TO: R. Bernero and M. Silberberg
FROM: A. B. Reynolds
SUBJECT: Comments on Source Term Review Second Meeting

Comments on Source Term Review from Second Meeting

A.B. Reynolds
University of Virginia

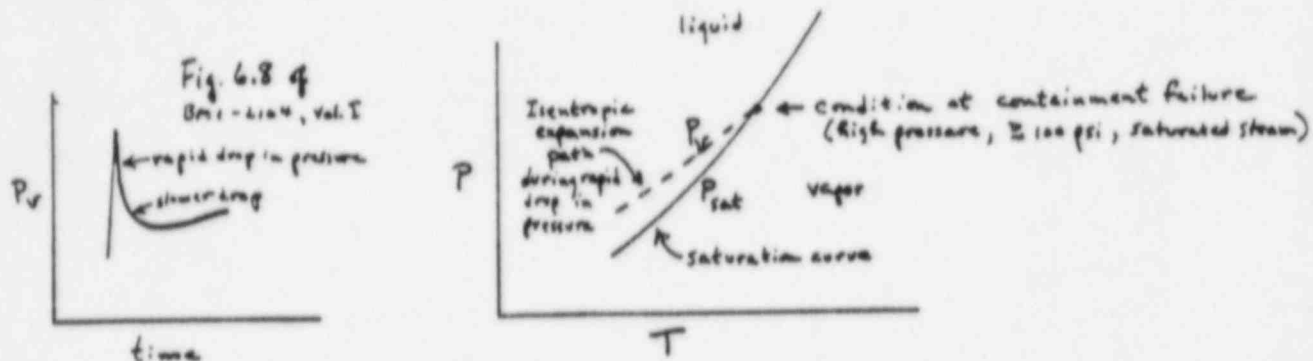
The steam leaving the containment would flow through the break in choked flow at first--either isenthalpically or isentropically. The steam remaining inside the containment would expand isentropically to continue to fill up the space in the containment, as shown by the dashed curve on the P,T diagram. Hence the steam would be supersaturated and would want to condense; the "supersaturation ratio", S , would be P_v/P_{sat} at the particular steam temperature. Nucleation would occur throughout the containment at a rate that can be calculated with reasonable confidence from classical nucleation theory. The nuclei would then grow into droplets as condensation proceeded. I would expect that a quite dense rain would occur that would sweep out most of the fission products and aerosols. On the other hand, the fog droplets might remain submicrometre in size, in which case they may not have time to settle out.
